RESPONSE TO COMMENTS

DRAFT ENVIRONMENTAL ANALYSIS

Advanced Clean Cars II Program

**California Air Resources Board
1001 I Street
Sacramento, California, 95814**

Figure A-1. New Resource Buildout Based on CPUC’s Preferred Portfolio²⁷

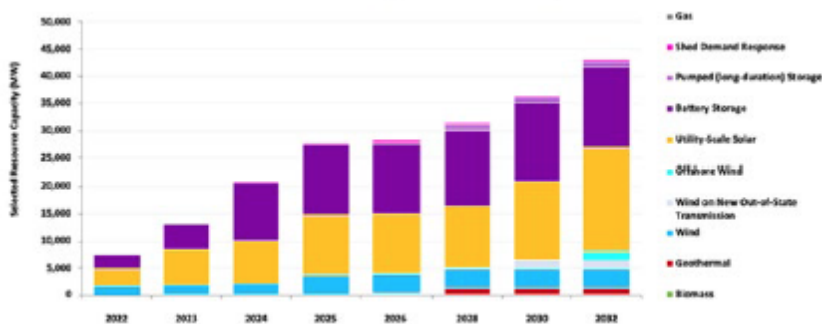
While securing additional generation capacity will mitigate some of these supply challenges, overreliance on renewable generation may exacerbate existing shortages, particularly during early evening hours. The California Public Utility Commission’s (CPUC) recently adopted Integrated Resource Plan for 2018-2020 demonstrates that substantial new resource capacity will be required to support accelerated electrification.²⁶ The CPUC’s preferred portfolio for electricity generation heavily relies on substantial scale-up of renewable resources that already face reliability challenges.

By 2026, when ACC II goes into effect, the CPUC must plan for a new resource buildout of 28,154 MW, climbing to 43,131 MW by 2032.²⁸ Nearly half of this capacity depends on battery storage, for which feasibility has not been demonstrated, and the majority of the remaining capacity is supplied by utility-scale solar, which also involves significant feasibility and reliability concerns.²⁹ Battery storage at this scale would result in significant additional demand for critical minerals, increasing consumer costs for both electricity and electric vehicles. CARB has failed to adequately assess these reliability challenges, despite its clear legal duty to do so.” (emph. orig., fn. omitted.)

Figure B-2. CARB ACC II Emissions Assessment Scope¹²³

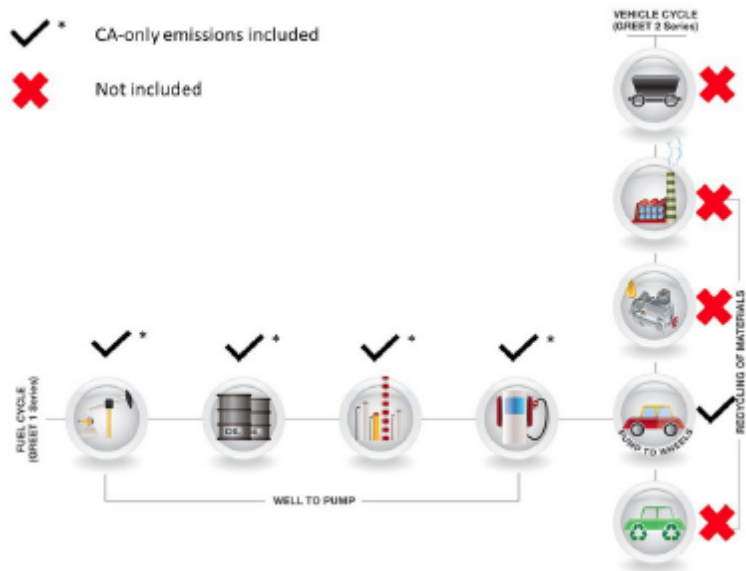
Figure B-2 below outlines the scope of the CARB ACC II emissions assessment and shows what components were included/considered and what was noticeably missing from the ISOR analysis. This figure was adapted from the GREET website and shows the components that make up a comprehensive vehicle life cycle assessment.

CARB has claimed that only in-state emissions for fuels were included due to an AB 32 emission boundary at state lines. However, this boundary is a regulatory-based line that is not representative of the actual behaviour of GHG emissions. GHG emissions are global pollutants that enter the atmospheric carbon stock and cause global consequences, no matter the point of origin. CARB must assess the full life cycle emissions associated with this regulation, regardless of location of the emission. Any assessment that does not recognize these impacts misrepresents the actual environmental effects of the proposed regulation and would lead to factually incorrect conclusions that undermine any rationale for adoption of the proposed rule.

Figure B-3: Vehicle Cycle GHG Emission Factors for Different Vehicle Technologies

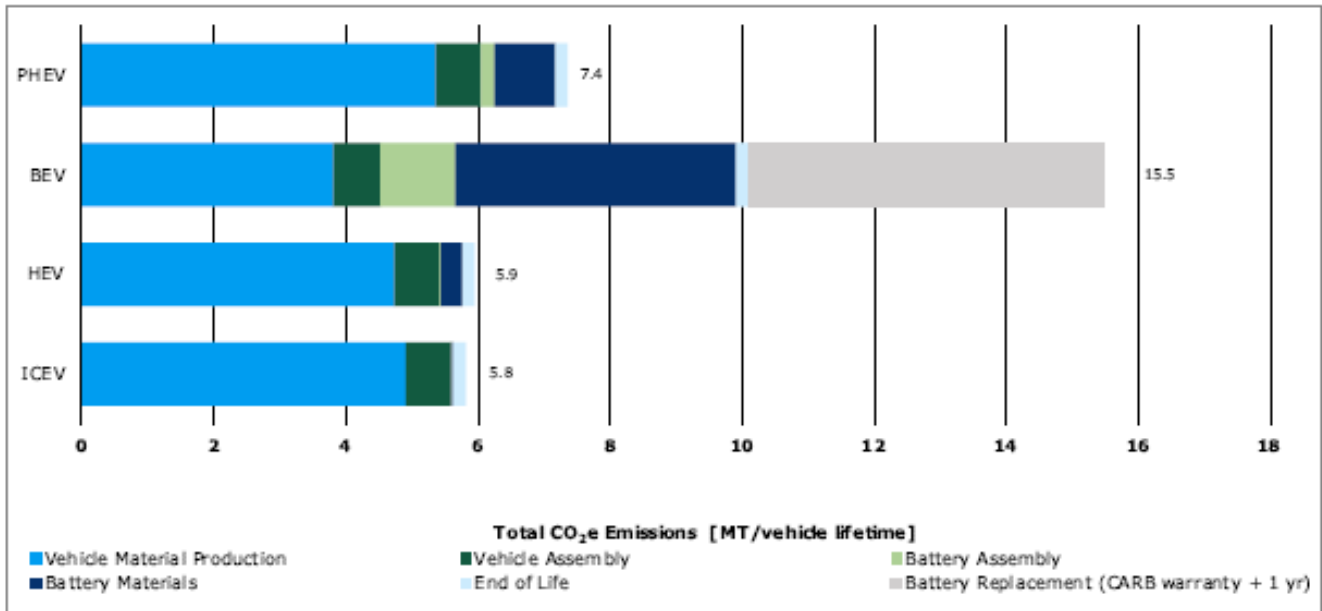
Vehicle cycle emissions¹²⁴ were not considered in the ISOR analysis but should be included due to the large differences in these emissions between ZEVs and ICEVs. The Ramboll LDA Study found that the vehicle cycle emissions for a model year 2026 BEVs (10.1 metric tons (MT) CO₂e per vehicle) was about 74% higher than those for a MY 2026 ICEV (5.8 MT CO₂e per vehicle) (see Figure B-3). If the BEV undergoes a battery replacement during its lifetime, its vehicle cycle emissions increase to 15.5 MT CO₂e per vehicle, which is ~167% higher than those of an ICEV. The significant emission increases associated with the production of a BEV, as compared to an ICEV, must be included in the ISOR emission analysis to fully understand the impacts of the proposed ACC II regulation.

Figure B-4: Capacity Analysis from CEC's EDGE Model¹²⁶ (dark red indicates no available additional capacity)

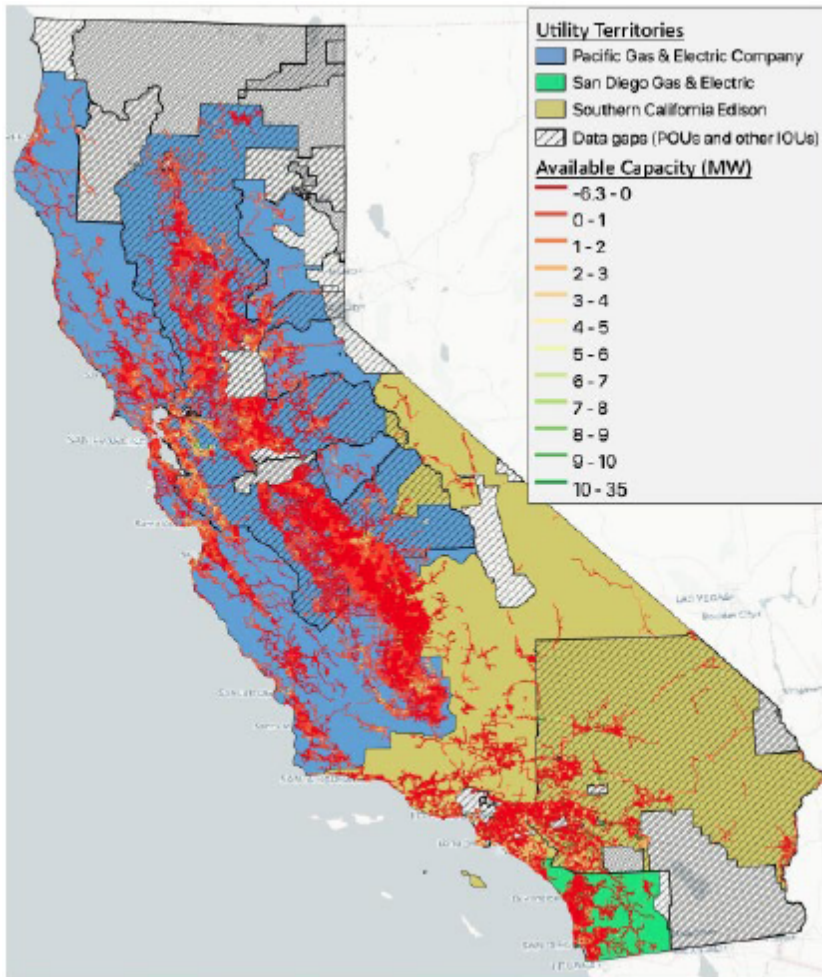
OP-161-24: The commenter states “**B.4 CARB does not discuss the potential impact to the California electric grid from this regulation including requirements for new and upgraded generation, transmission, and distribution.**”

CARB has not provided any analysis of the feasibility of the proposed regulation given the significant increase of charging infrastructure, electrical generation and transmission and distribution infrastructure that would be required to support a ZEV fleet. The Capacity Analysis from CEC’s EDGE Model (**Figure B-4** below, obtained from Page 48 in the Draft EA125) shows the grid has no additional capacity to add electrical load for charging for most of these circuits. You can see this in numerical terms in **Figure B-5** (obtained from Virtual Medium and
